**MD 121 & I-270 Interchange Improvements, Mandatory Referral No. 2014049**

**Completed: 09/23/2014**

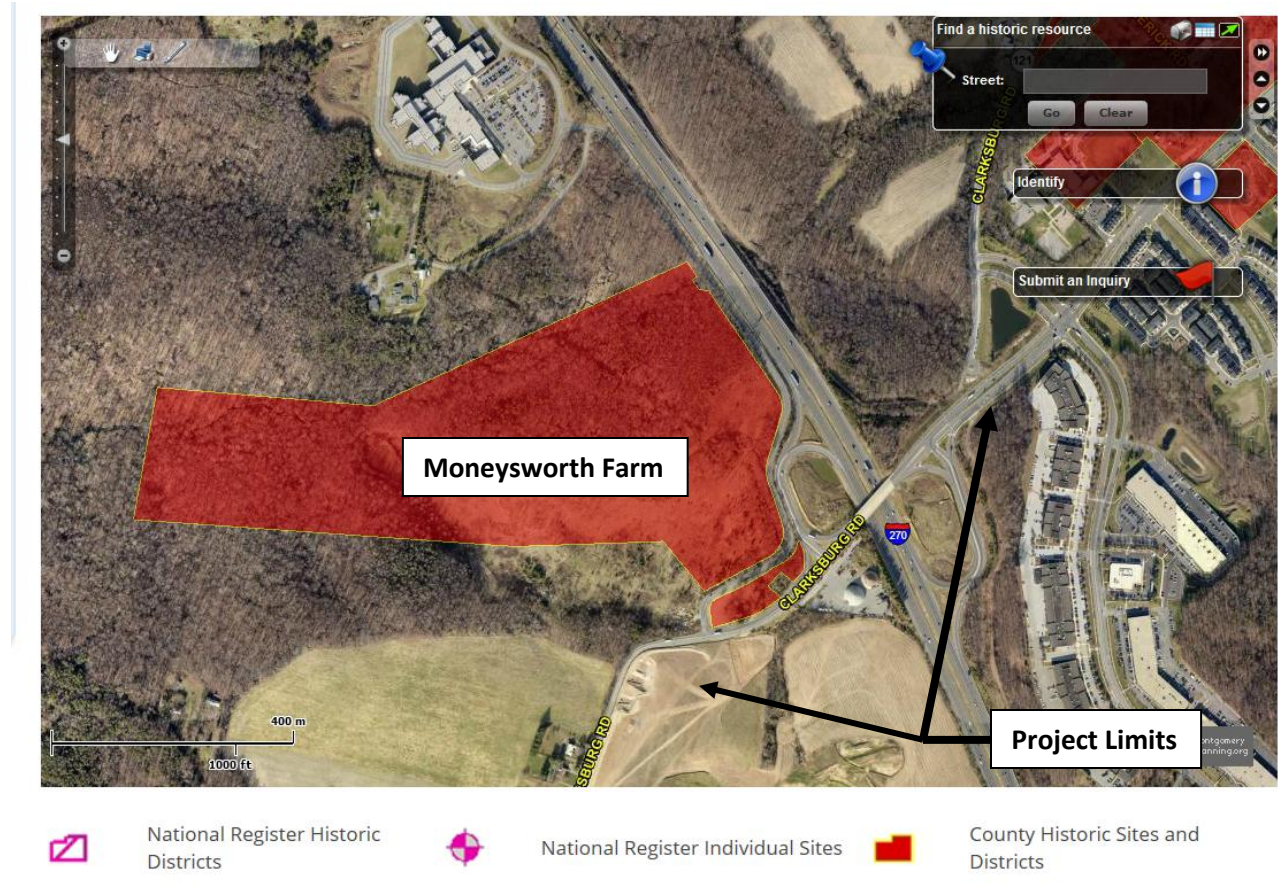
On-road bicyclists would be accommodated along MD121 via 5'-7' wide bike lanes. Off-road bicyclists would be accommodated along MD121 via a shared use path that transitions from the west side of MD121 east of I-270 to the east side of MD121 west of I-270; the crossing point would be at the proposed traffic signal at the Ramp G terminus west of I-270.

Pedestrians would be accommodated along MD121 via a five-foot-wide sidewalk or the eight-foot-wide shared use path on either side of the roadway.
